UNITED STATES PATENT AND TRADEMARK OFFICE

APPLICATION NO.	FILING DATE	FIRST NAMED INVENTOR	ATTORNEY DOCKET NO.	CONFIRMATION NO.
10/711,913	10/13/2004	Chia-Tsui Lan	17389.75	5912
22913	7590	01/10/2008		
WORKMAN NYDEGGER 60 EAST SOUTH TEMPLE 1000 EAGLE GATE TOWER SALT LAKE CITY, UT 84111			EXAMINER LIANG, LEONARD S	
			ART UNIT 2853	PAPER NUMBER
			MAIL DATE 01/10/2008	DELIVERY MODE PAPER

Office Action Summary	Application No.	Applicant(s)	
	10/711,913	LAN, CHIA-TSUI	
	Examiner	Art Unit	
	Leonard S. Liang	2853

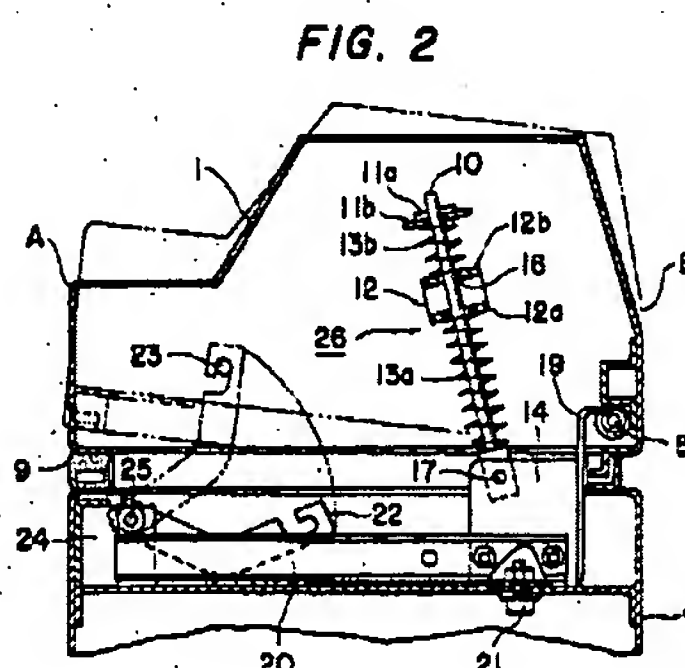
Miyasaka et al discloses:

- {claim 1} A machine body (figure 2); a housing (figure 2); an upper body capable of being positioned at a range of angles relative to the housing (figure 2, reference 1); and a hinge (figure 2, reference 5) comprising a support shaft (figure 2, reference 10) connected to the upper body; and a support block (figure 2, reference 12) connected to the housing, the support block comprising a hole (figure 2, reference 16), and the support shaft passing through the hole (figure 2, reference 10) and capable of moving up and down along the hole (column 1, lines 43-47)

- {claim 2} wherein the support block is rotatably connected to the housing (figure 2, reference 12)
- {claim 3} wherein the hole is a cylindrical hole and the support shaft is a cylindrical shaft (figure 2, reference 10, 16)

- {claim 4} wherein the area of the cross section of the support shaft is constant over the length of the support shaft (figure 2, reference 10)
- {claim 7} wherein at least one section of the support shaft tightly fits the support block (figure 2, reference 10, 12)

- {claim 11} wherein the support shaft comprises a cylindrical shaft and wherein the hold comprises a cylindrical hole (figure 2)
- {claim 25} An apparatus (figure 2) comprising: means for coupling an upper body to a housing (figure 2), wherein the means for coupling comprises means for connecting a support shaft to the upper body (figure 2, reference 10), and means for supporting the support shaft in a sliding manner (through reference 12), and the means for supporting interfacing with the housing, wherein the upper body is capable of being positioned at any of a range of angles relative to the housing due to a frictional relationship defined by the means for supporting and the support shaft (figure 2)

- {claim 26} further comprising means for rotatably connecting the means for supporting to the housing (figure 2)
- {claim 27} wherein the means for supporting the support shaft comprises a support block that defines a straight hole and the support shaft comprises a straight shaft (figure 2)
- {claim 28} wherein means for supporting the support shaft comprises a support block that defines a straight cylindrical hole and the support shaft comprises a straight cylindrical shaft (figure 2)
- {claim 29} wherein the area of the cross section of the support shaft is constant over the length of the support shaft (figure 2)
- {claim 34} further comprising a joint axle by way of which the housing is rotatably attached to the upper body (figure 2, reference 17)
